Department of Transportation

MEMORANDUM

SUBJECT: ZC Case No. 18-22 – The Yards Parcel G

Figure 1 – Site Plan (Source: CTR, Gorove/Slade, Figure 7, 3/25/19)

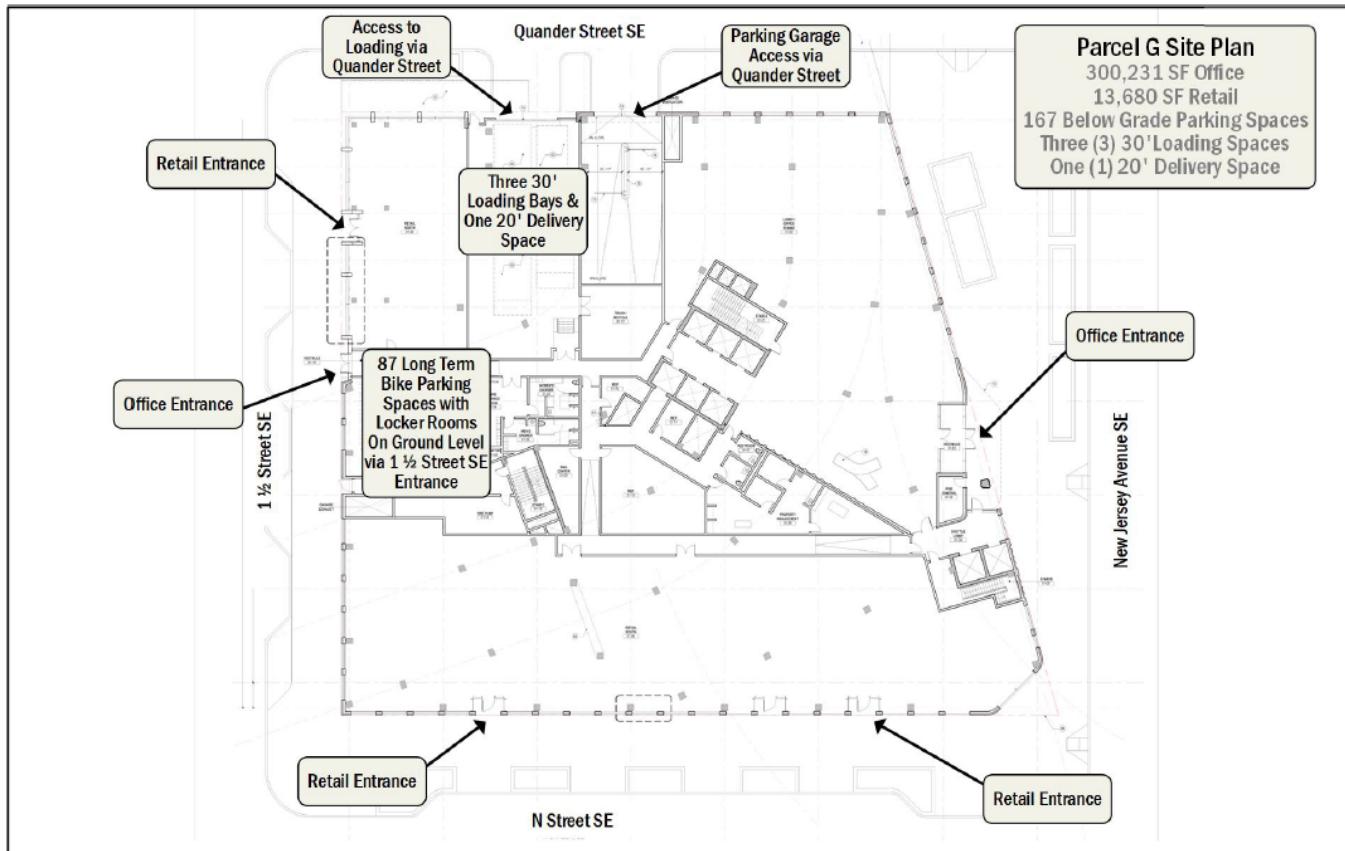
- Finalize design of Quander Street SE curb cuts at both New Jersey Avenue and 1st Street. Curb ramps and crosswalk across Quander Street should be straight across, not at an angle;

- Finalize design of southeast corner of site, including relocating the curbs, to accommodate the ultimate design of Tingey Square;
- Finalize design of raised intersections, curbless street concept, bollards, and signage where private 1 ½ Street crosses public N Street;

- Maximize the number of street trees in public space, including the addition of trees in the southeast corner of the property at Tingey Square;
- While not in DDOT-controlled public space, DDOT recommends including additional street trees along the southern side of Quander Street. It appears there is space to add at least 1 or 2 more;

- Determine final locations for the short-term bicycle parking spaces (approx. 6 inverted U-racks) which should be in easily accessible locations, near retail entrances, and preferably within the “furniture zone” near the curb in public space or along 1 ½ Street SE.
